Re: Step Rate Injection Test
Calpine Natural Gas Company
Roosevelt SWD #1
SE/4 Section 22, T30N, R14W

Calpine Natural Gas Company performed a step-rate injection test on their Roosevelt SWD #1 disposal well on November 3, 2003. Based on the results of this test, Calpine Natural Gas requests an increase in the maximum allowable injection pressure to 1075 psi, measured at the surface.

From: Chavez, Frank
Sent: Friday, November 14, 2003 8:22 AM
To: Jones, William V
Cc: Perrin, Charlie
Subject: Calpine Step Rate Test

EXHIBIT #2

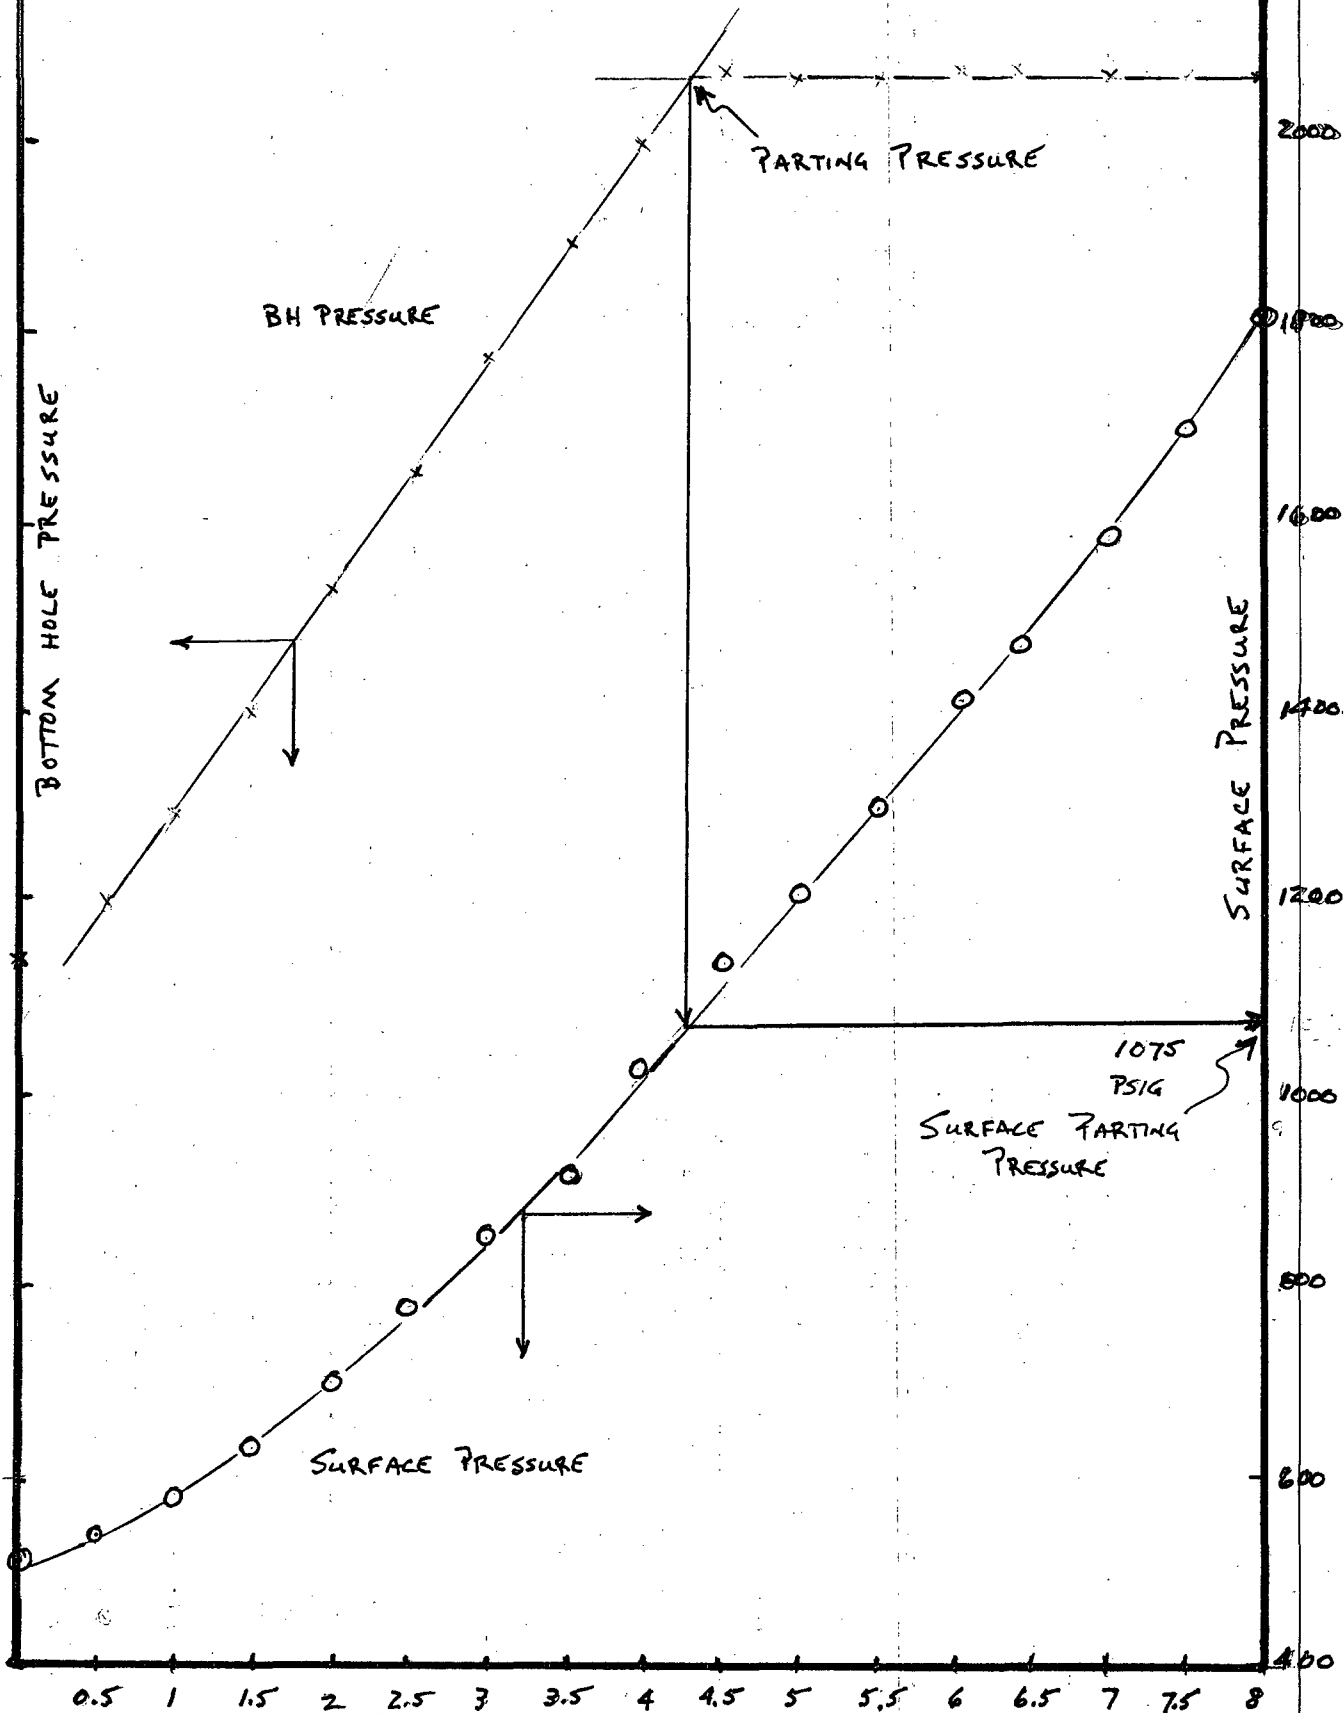
We agree that the parting occurs between 4 and 4.5 BPM.
